RE: Nine Mile Point Unit 1
Docket No. 50-220
DPR-63

Subject: *Request for Additional Information Regarding Proposed Amendment on Thermal-Hydraulic Stability, Nine Mile Point Nuclear Station, Unit No. 1 (TAC No. MA4218)*

REQUEST FOR ADDITIONAL INFORMATION REGARDING PROPOSED TECHNICAL SPECIFICATION CHANGE CORE THERMAL-HYDRAULIC STABILITY NIAGARA MOHAWK POWER CORPORATION NINE MILE POINT NUCLEAR STATION, UNIT NO. 1 DOCKET NO. 50-220

FIVE LOOP OPERATION

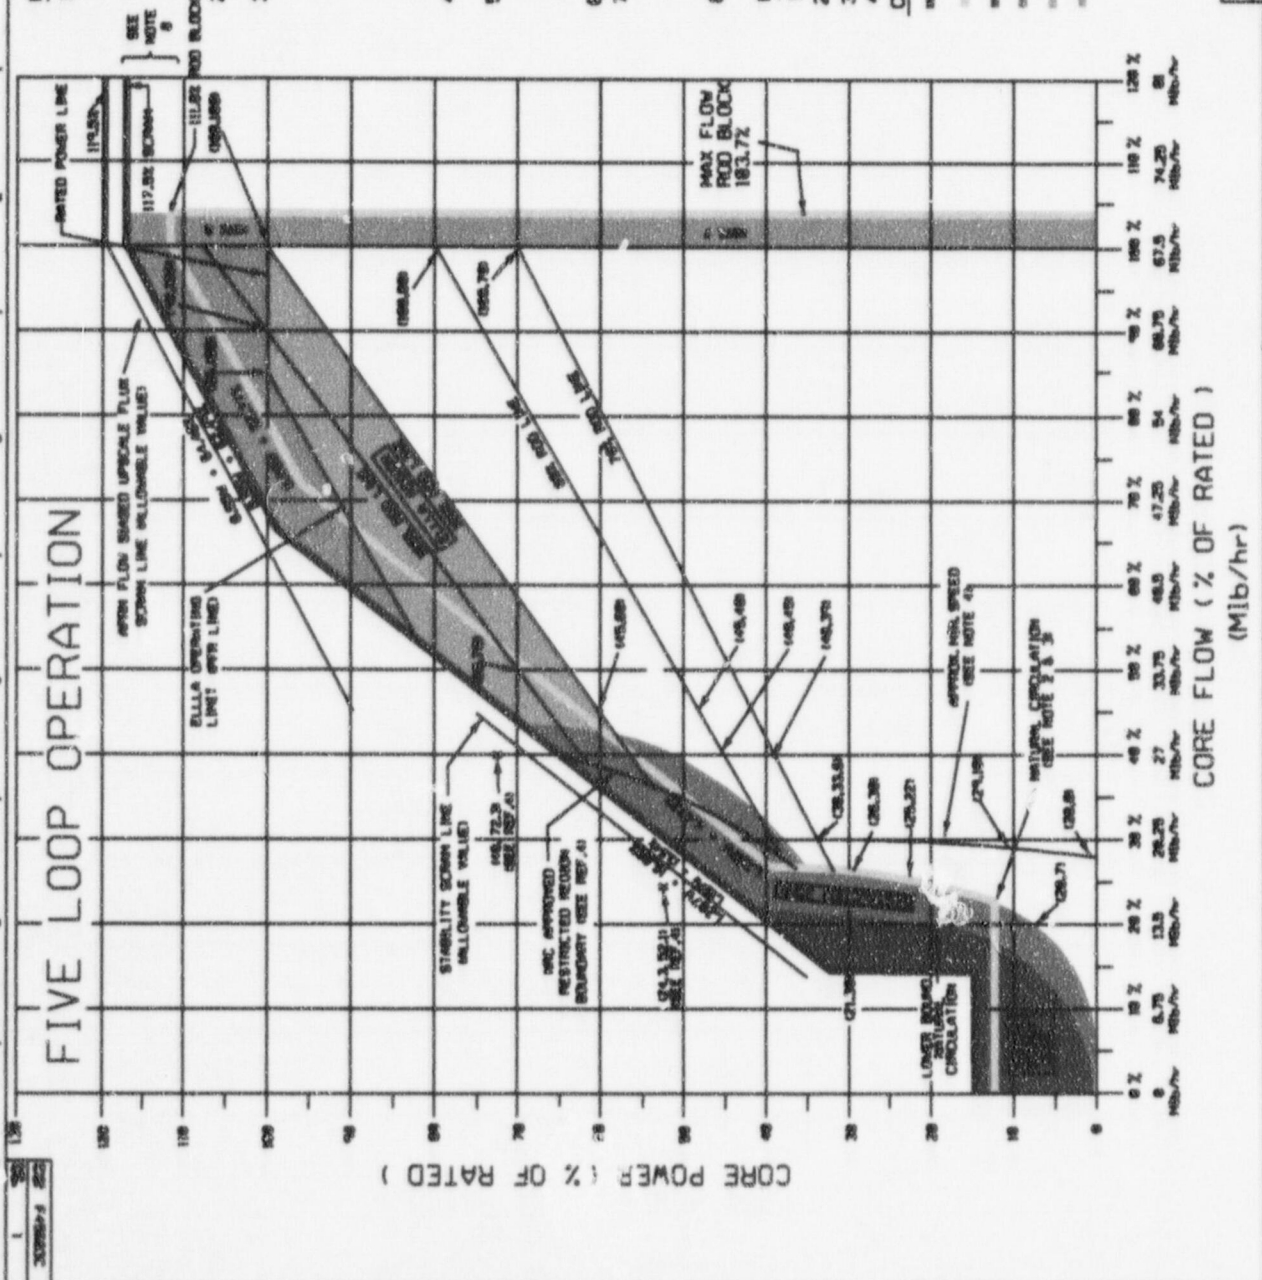
1. *Provide a schematic showing the approved ELLLA region versus the power/flow restriction region. Describe the relationship in terms of the necessity of the increment of 2% for the upper APRM flow-biased neutron flux scram setting and 7% for APRM rod block trip settings. Justify that these proposed TS changes are still within the approved ranges of the NMP1 stability long-term solution II proposed in GENE-A13-00360-02.*

Enclosure 1 to this Attachment provides a schematic showing the Extended Load Line Limit Analysis (ELLLA) region versus the power/flow restriction region.

Our November 16, 1998 submittal proposed essentially two changes to the Nine Mile Point Unit 1 (NMP1) Technical Specifications (TSs). Specifically, changes were proposed to the APRM flow-biased neutron flux scram and rod block settings in the high flow region and low flow region of the power/flow map. In the high flow region of the power/flow map, Niagara Mohawk Power Corporation (NMPC) proposed a 2% increase and 7% increase in the analytical flow-biased scram and control rod block limits, respectively. This increase was proposed to allow plant operation in the previously approved ELLLA region.

NMP1 is currently restricted from full use of the ELLLA region of the power/flow map because of the setpoints for the flow-biased rod block. The setpoint methodology used assigns a penalty to account for drift of the power and flow measuring instruments. This penalty reduces the as-left setpoints of the rod block which causes it to fall into the allowable ELLLA region. Consequently, NMP1 is forced to operate at higher core flows to avoid rod block alarms. Full use of the ELLLA region will allow for optimum core power distributions throughout the operating cycle and a gain in cycle energy. Operation in the ELLLA region was approved by Amendment No. 92 dated March 24, 1987.

The current values of the APRM flow-biased neutron flux scram and rod block settings are 120% and 110%, respectively (i.e., a 10% margin between the scram and rod block settings currently exists). Prior to our November 16, 1998 TS Application, an analysis had been

performed to support a 2% increase in the APRM flow-biased scram analytical limit. Accordingly, a new scram limit of 122% is proposed. Regarding the control rod block setting, calculation demonstrated that a 5% margin between the scram and rod block limits was acceptable (i.e., $122\% - 5\% = 117\%$). The proposed control rod block setting of 117% represents the 7% increase from the current value of 110%.

In the low flow region of the power/flow map, more conservative TS APRM flow-biased scram and control rod block setpoints were proposed. The scram value calculated will limit the oscillation magnitude assuring that the plant MCPR safety limit value is not exceeded. As shown on the attached schematic, the APRM flow-biased setpoints are based on GENE-A13-00360-02.
